Review of Pape Avenue TOC Noise and Vibration Considerations

Ontario Line Technical Advisor

December 2022

Plot Date: 2022-10-24 5:59:53 PM	
Infrastructure Ontario	
SCALE 1 : 200	DRAWING NUMBER 413T201N

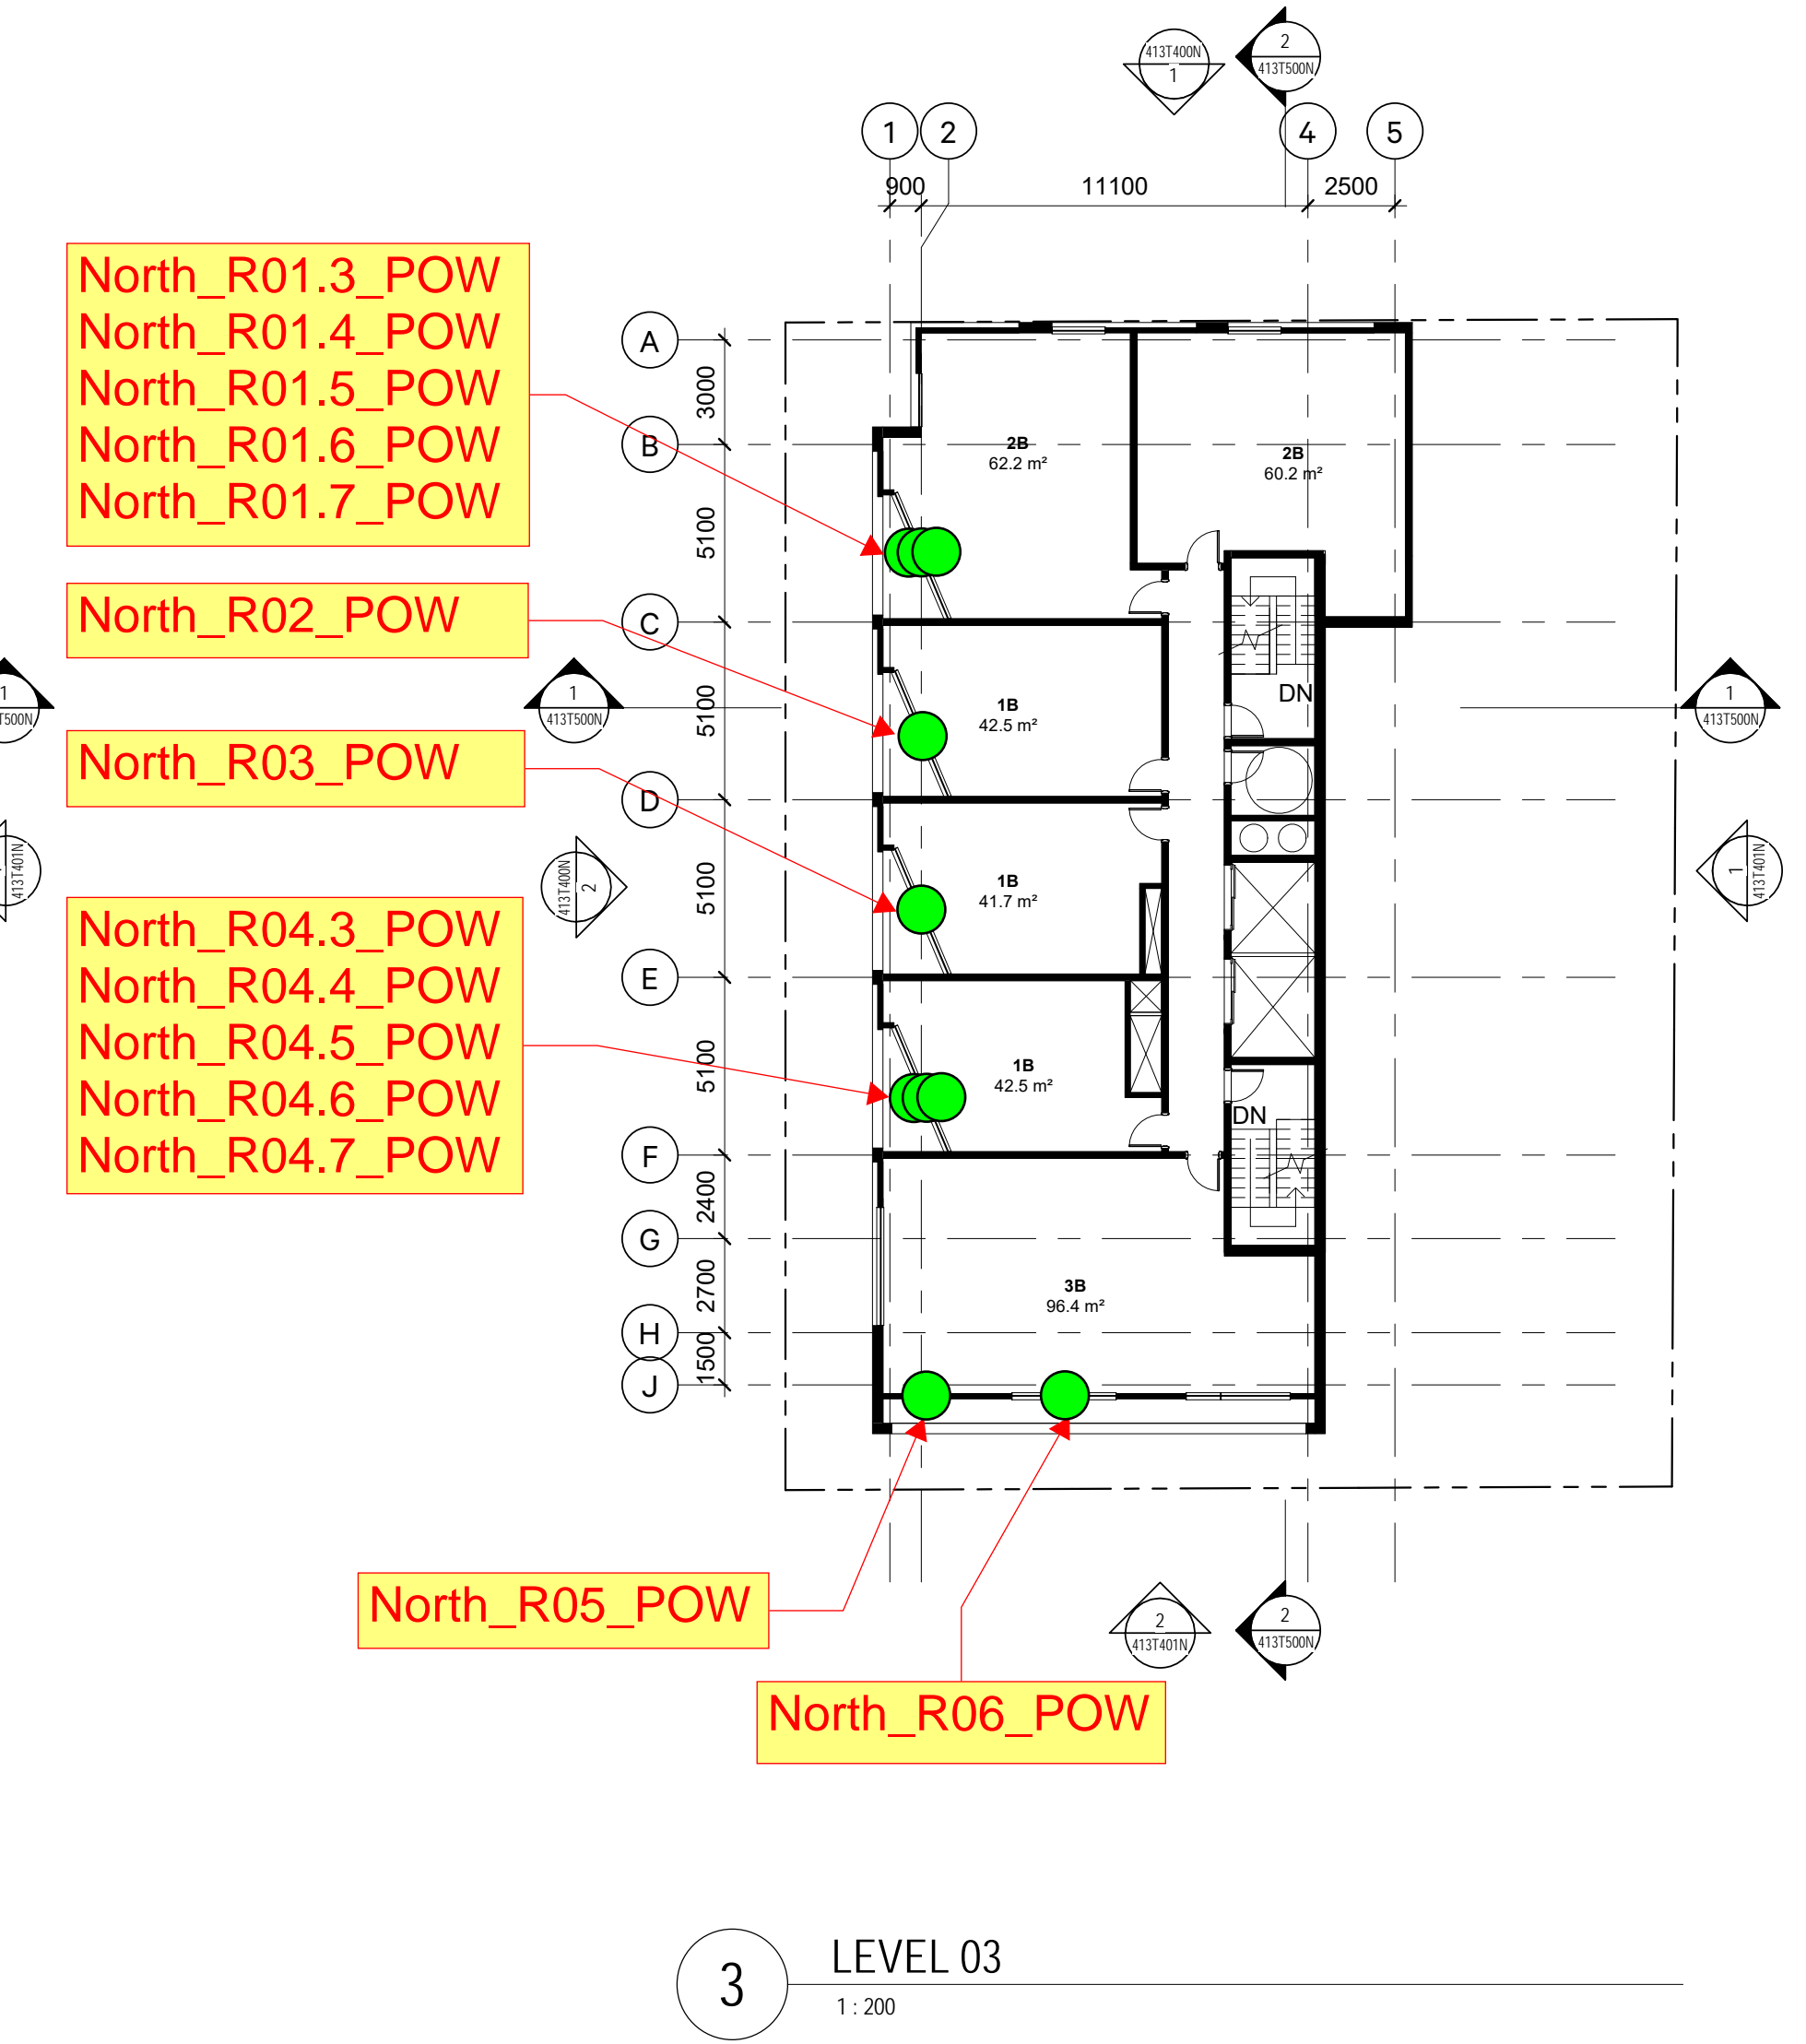
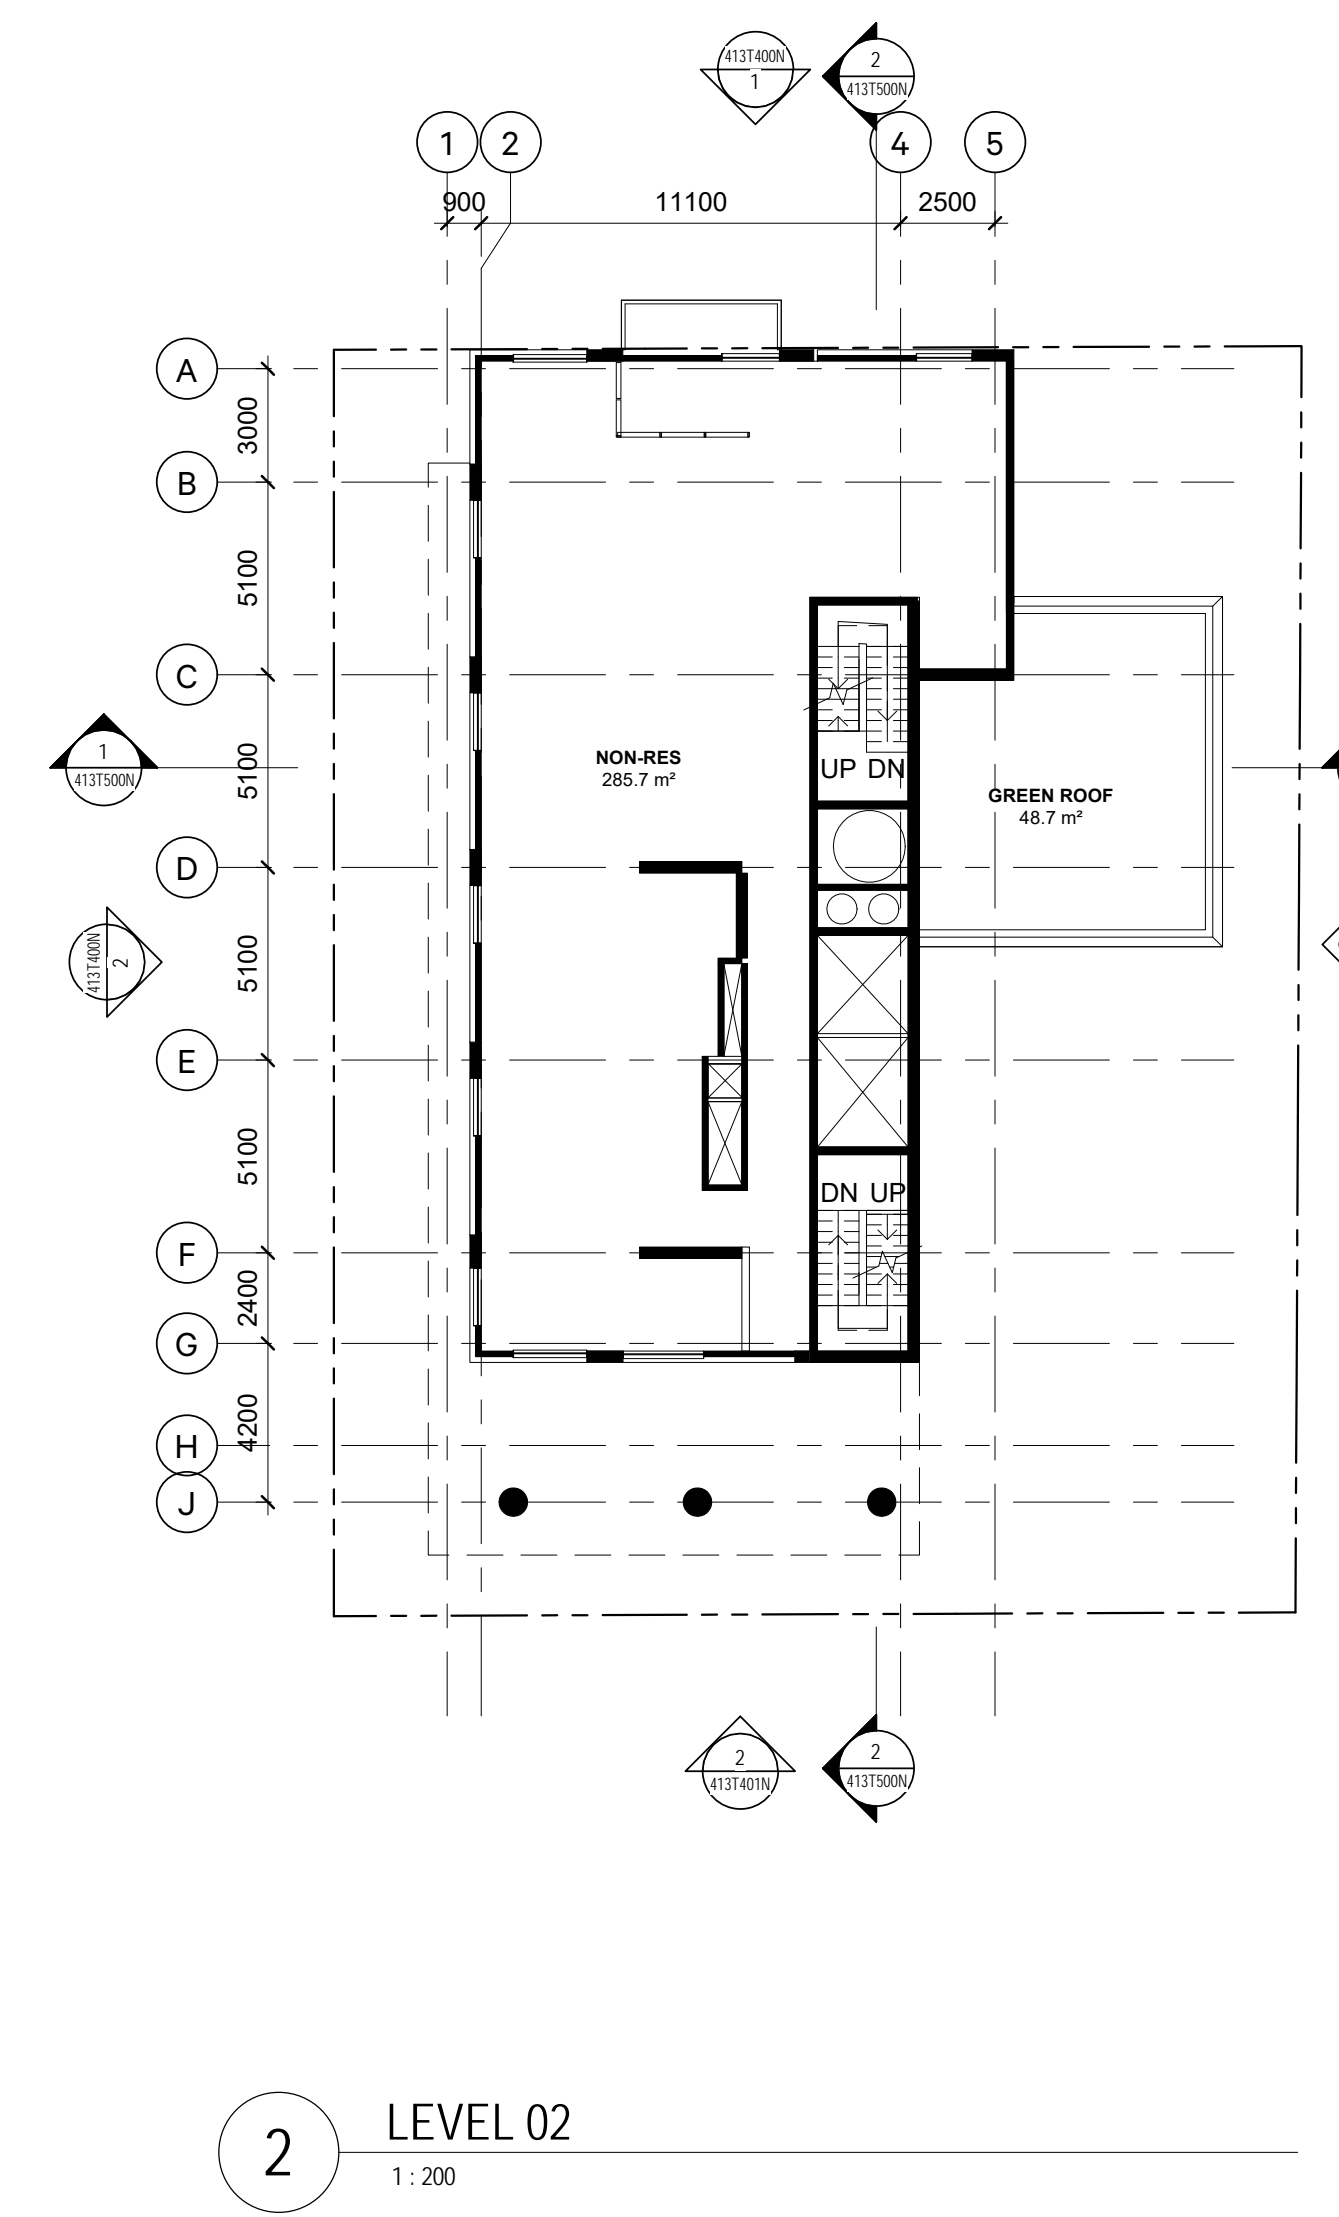
The predicted noise levels from the station noise sources show that sound levels at most the POW receptors are expected exceed Class 1 nighttime noise limit of 45 dBA. Noise levels without TTC busses were also predicted at the receptors and presented for information purpose.

1. Section lines from drawings 413T201N and 413T202N.
2. Plane of Window nighttime noise limit for Class 1 Area, MECP NPC-300.

- Adding enclosed balconies for the areas where exceedance is identified (i.e., North Site and South Site balconies facing the EEB condenser yard and ventilation openings).
- Moving residential units away from the impacted areas and/or positioning sleeping areas to the sides of the building not facing the station noise sources.
- Incorporating other massing design changes to provide additional shielding from noise sources⁴.
- Criteria adjustments by consideration of a Class 4 acoustical area designation by the land use planning authority, discussed below.
